**Champlain Hudson Power Express ("CHPE")
Environmental Management & Construction Plan
Notice of Major Change**

Project: Champlain Hudson Power Express

Segment: 9

Notice Number: 123

PERMIT DRAWING NO.	
DRAWING NO.	C-310

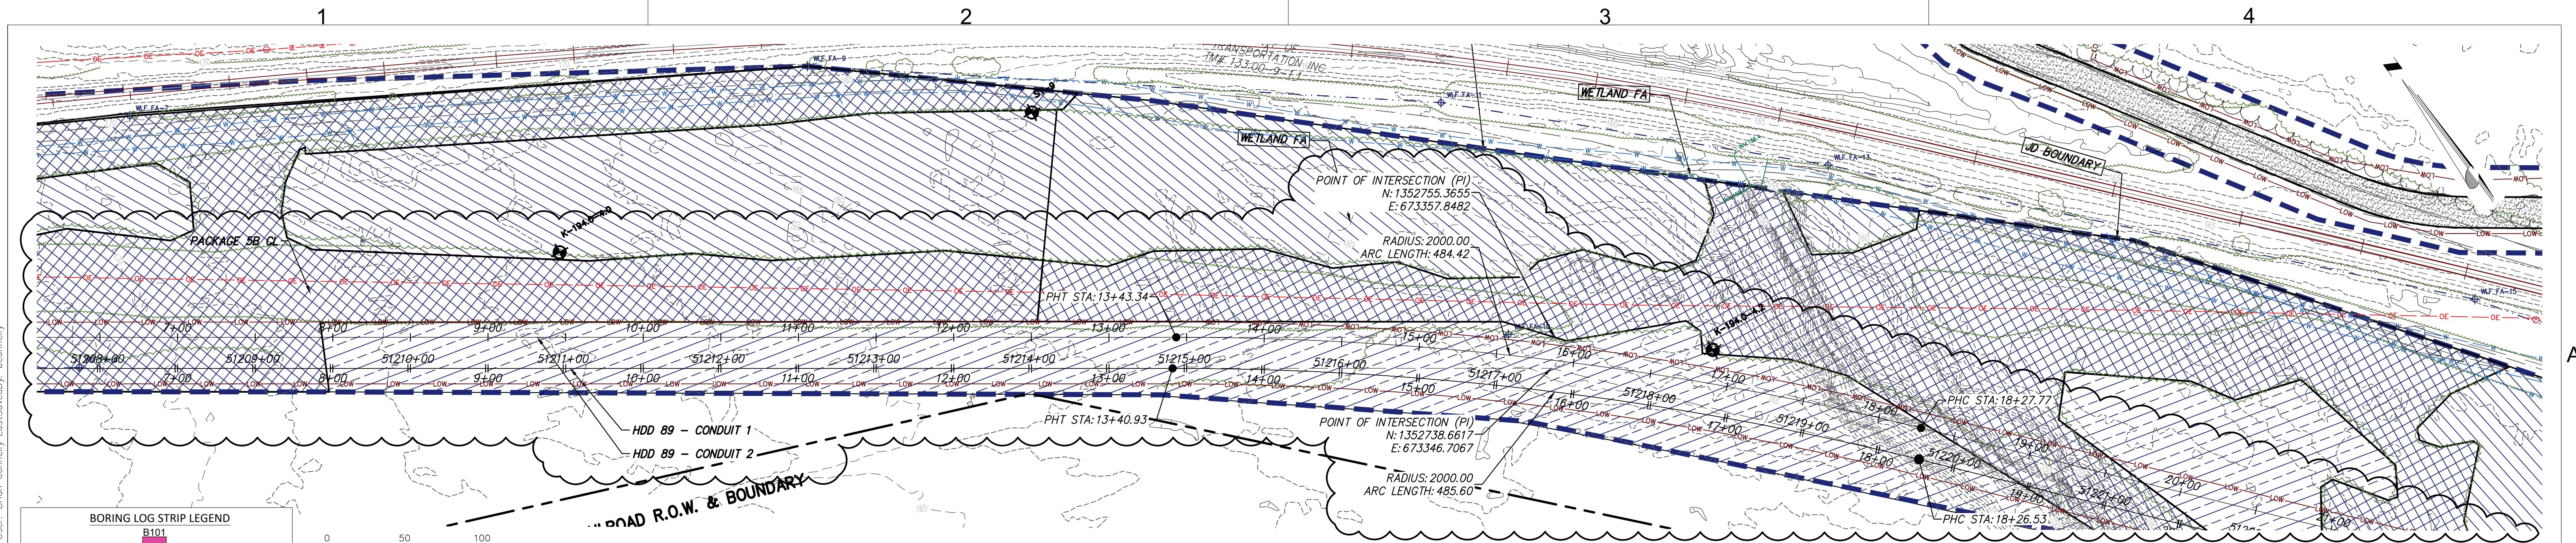
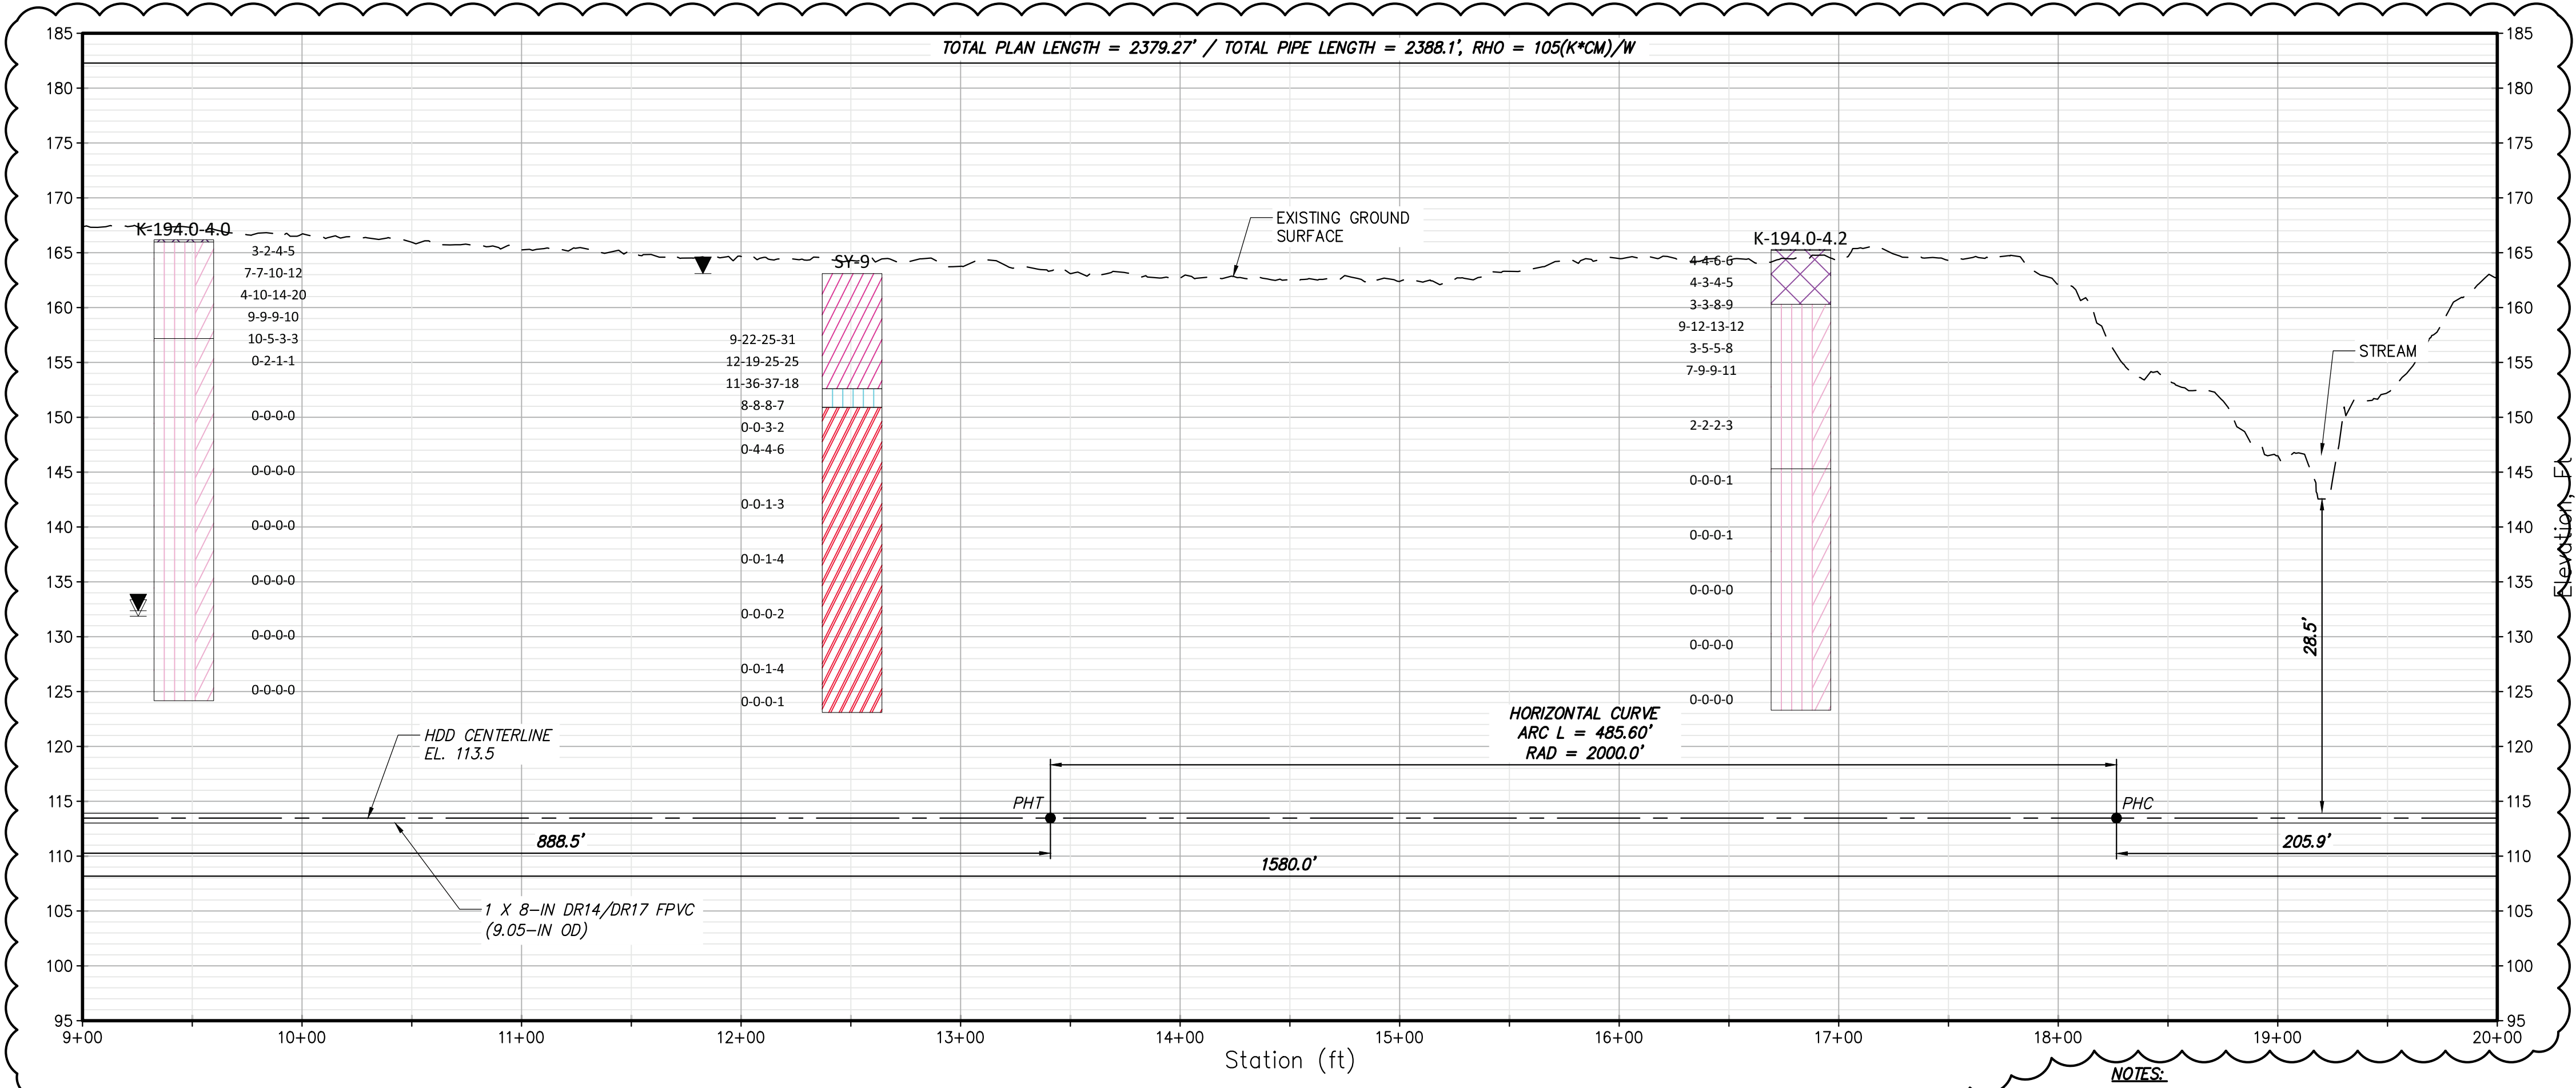
Sheet No.	Rev No.	Revision Description	Summary of Plan Changes
C-114	1	NDC-0005_ALIGNMENT REVISIONS PER NAT. GRID COMMENT	Alignment of HDD adjusted to avoid crossing underneath National Grid overhead electric sub-transmission line from STA 51200+00 to STA 51220+00. Extended HDD 89 workspace in front of pits and adjusted LOW and permanent easement accordingly. Corrected wire pull 191 Direction of cable pull to the preferred reverse direction.
C-115	1	NDC-0005_ALIGNMENT REVISIONS PER NAT. GRID COMMENT	Alignment of HDD adjusted to avoid crossing underneath National Grid overhead electric sub-transmission line from STA 51200+00 to STA 51220+00. Extended HDD 89 workspace in front of pits and adjusted LOW accordingly.
C-116	1	NDC-0005_ALIGNMENT REVISIONS PER NAT. GRID COMMENT	Alignment of HDD adjusted to avoid crossing underneath National Grid overhead electric sub-transmission line from STA 51200+00 to STA 51220+00. Extended HDD 89 workspace in front of pits and adjusted LOW accordingly. Corrected wire pull 193 Direction of cable pull to the preferred reverse direction.

No.	DATE	SUBMITTAL / REVISION DESCRIPTION	DB	APP
1	04/19/2024	NDC-0005_ALIGNMENT REVISIONS PER NAT. GRID COMMENT	NS	BD
0	06/09/2023	ISSUED FOR CONSTRUCTION SUBMISSION	NS	BD

PERMIT DRAWING NO.
DRAWING NO.
C-312

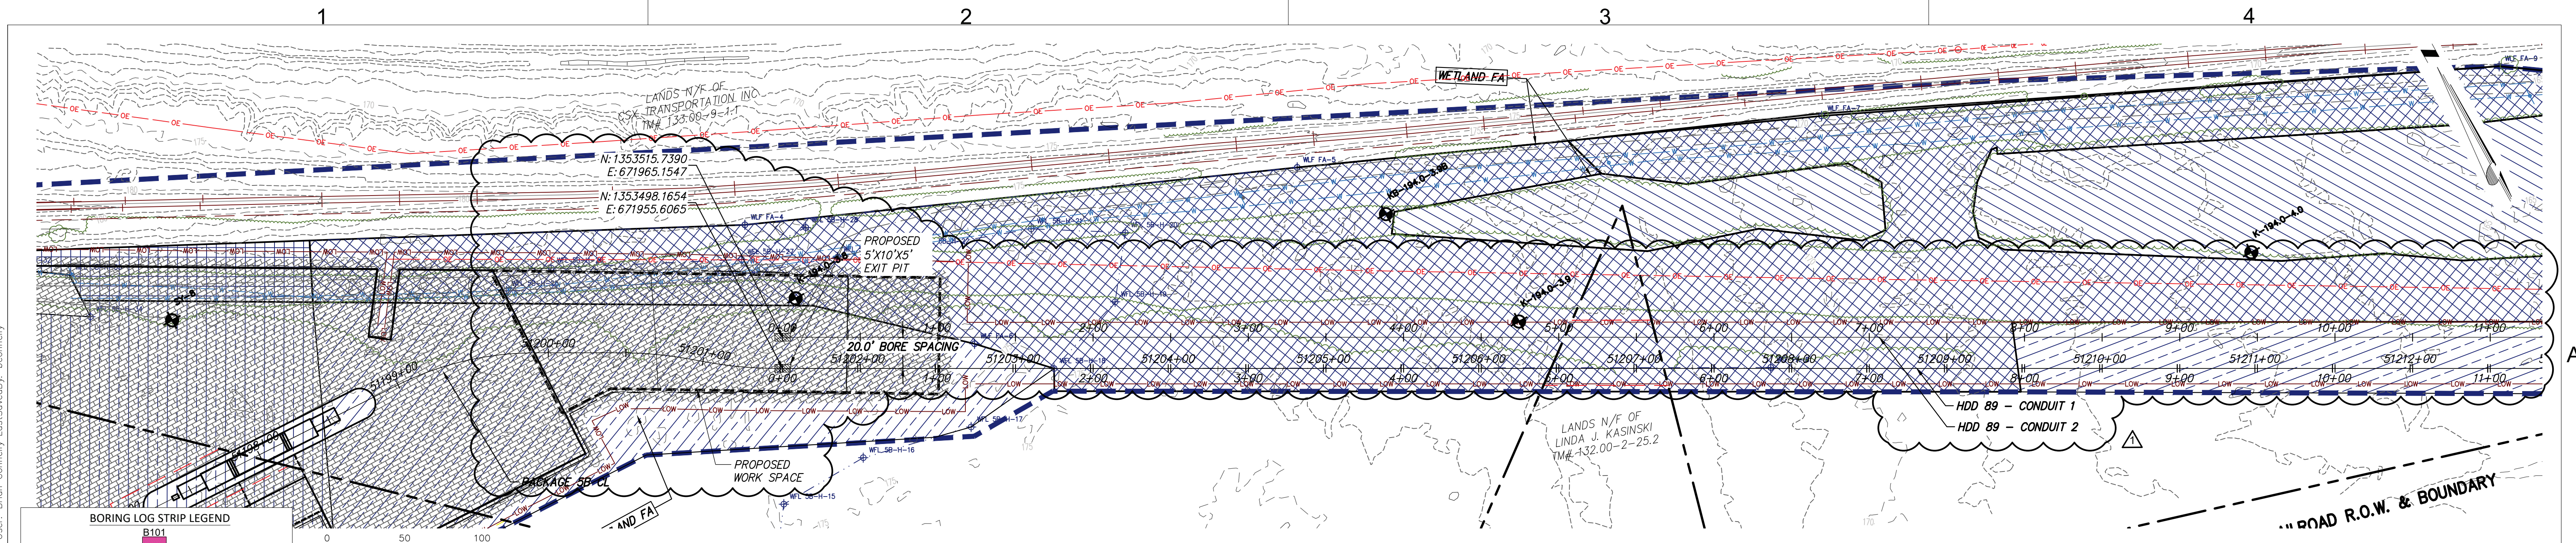
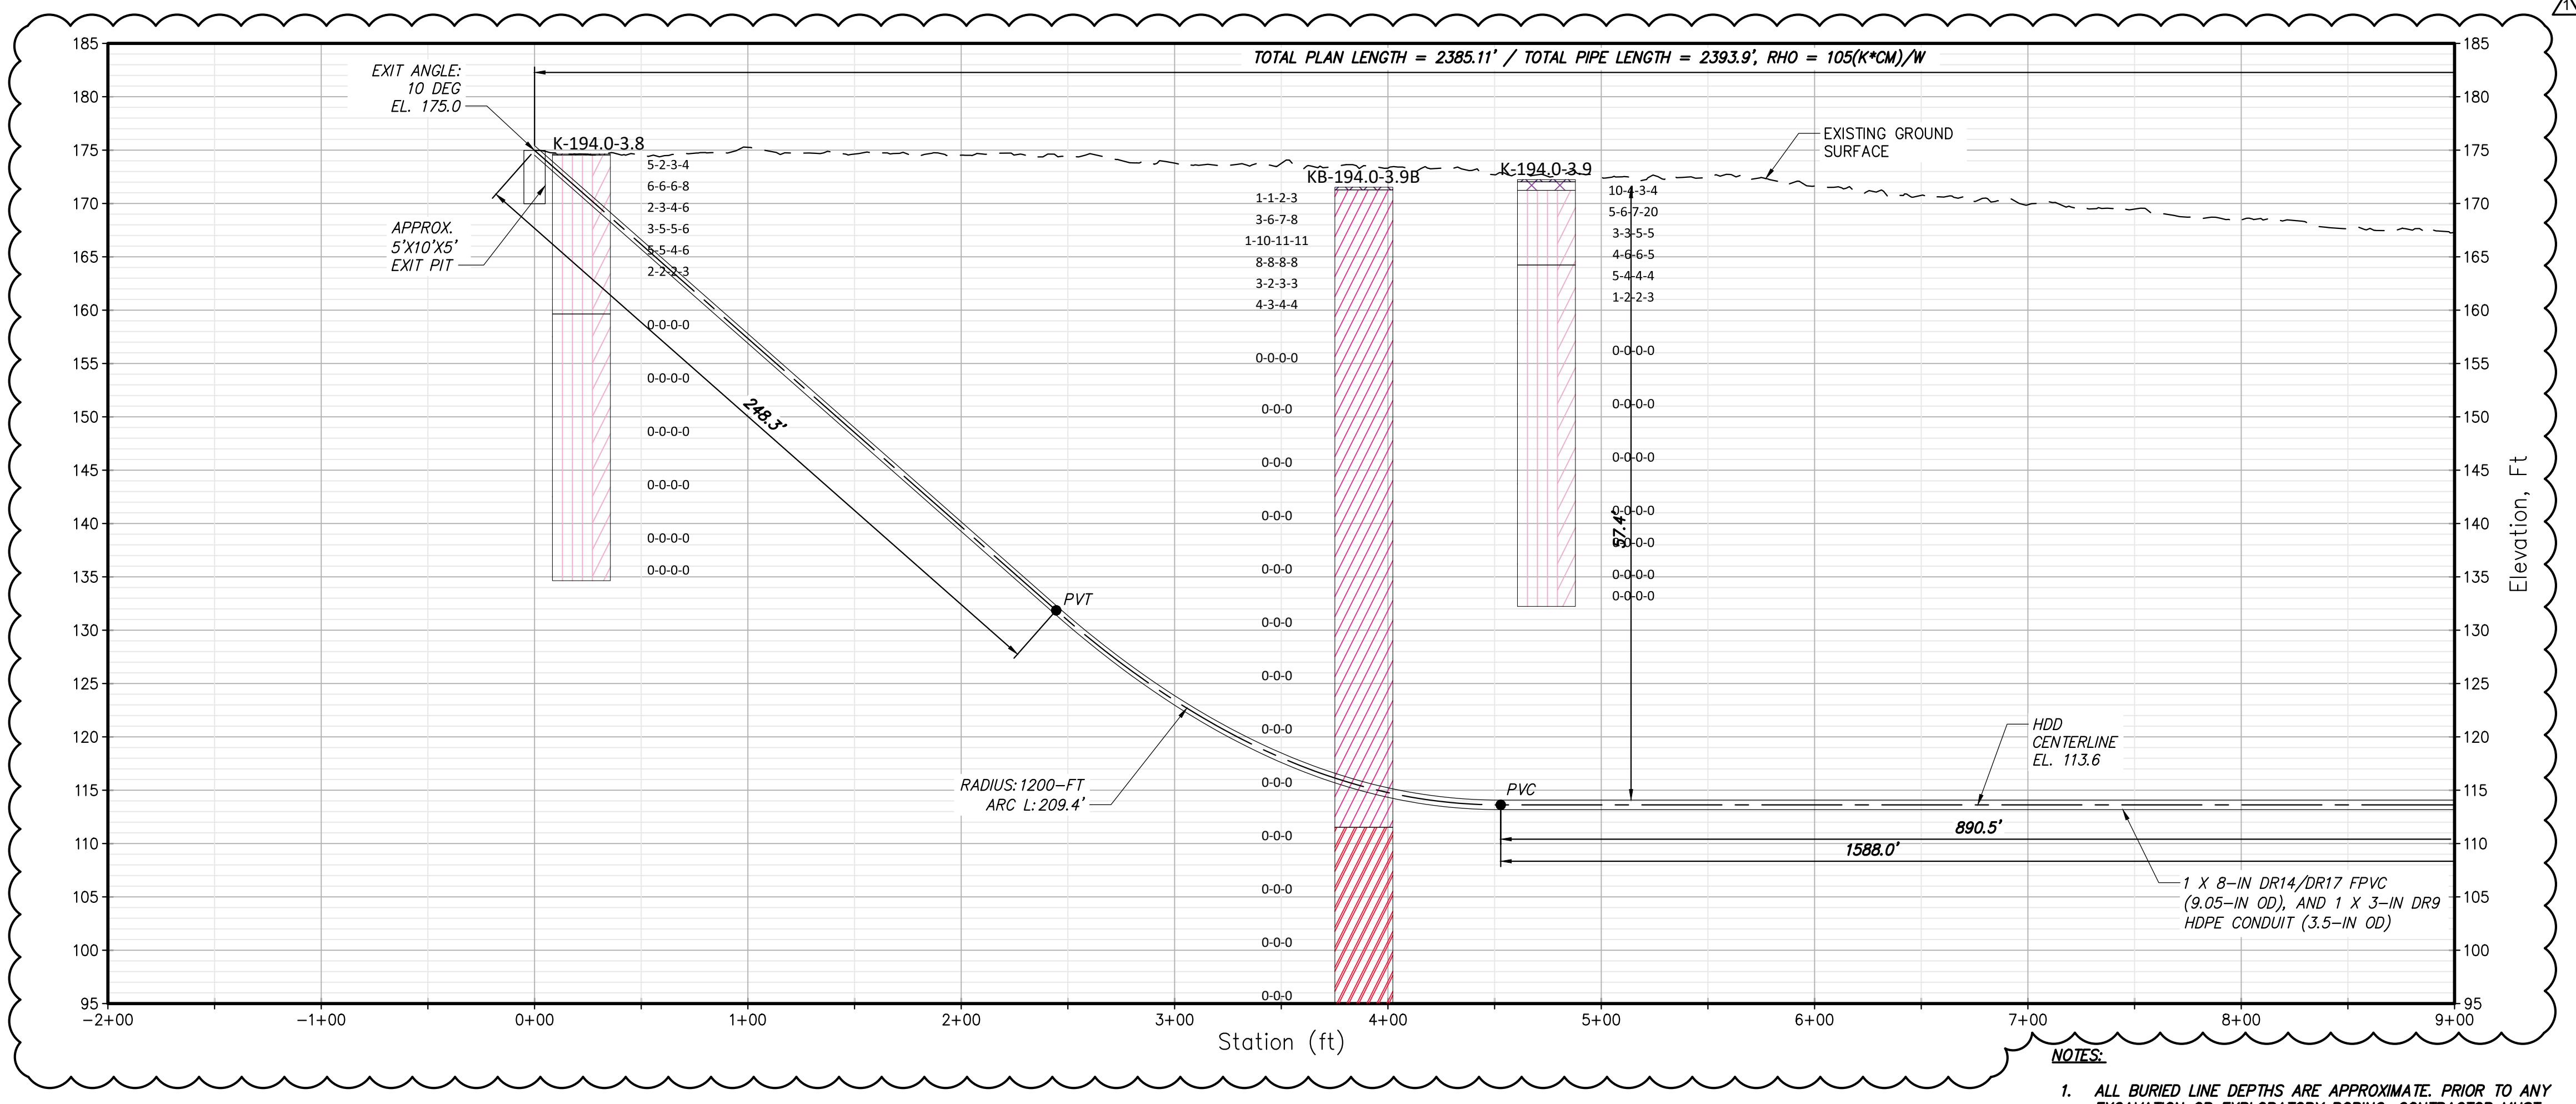
C-312	1	NDC-0005_ALIGNMENT REVISIONS PER NAT. GRID COMMENT	Alignment of HDD adjusted to avoid crossing underneath National Grid overhead electric sub-transmission line from STA 51200+00 to STA 51220+00. Revised HDD Conduit Material Type and size. Corrected fiber conduit callouts to denote bundling of fiber with Conduit 2.
C-313	1	NDC-0005_ALIGNMENT REVISIONS PER NAT. GRID COMMENT	Alignment of HDD adjusted to avoid crossing underneath National Grid overhead electric sub-transmission line from STA 51200+00 to STA 51220+00. Revised HDD Conduit Material Type and size. Corrected fiber conduit callouts to denote bundling of fiber with Conduit 2.
C-314	1	NDC-0005_ALIGNMENT REVISIONS PER NAT. GRID COMMENT	Alignment of HDD adjusted to avoid crossing underneath National Grid overhead electric sub-transmission line from STA 51200+00 to STA 51220+00. Revised HDD Conduit Material Type and size. Corrected fiber conduit callouts to denote bundling of fiber with Conduit 2.

No.	DATE	SUBMITTAL / REVISION DESCRIPTION	DB	APP
1	04/19/2024	NDC-0005_ALIGNMENT REVISIONS PER NAT. GRID COMMENT	NS	BD
0	06/09/2023	ISSUED FOR CONSTRUCTION SUBMISSION	NS	BD
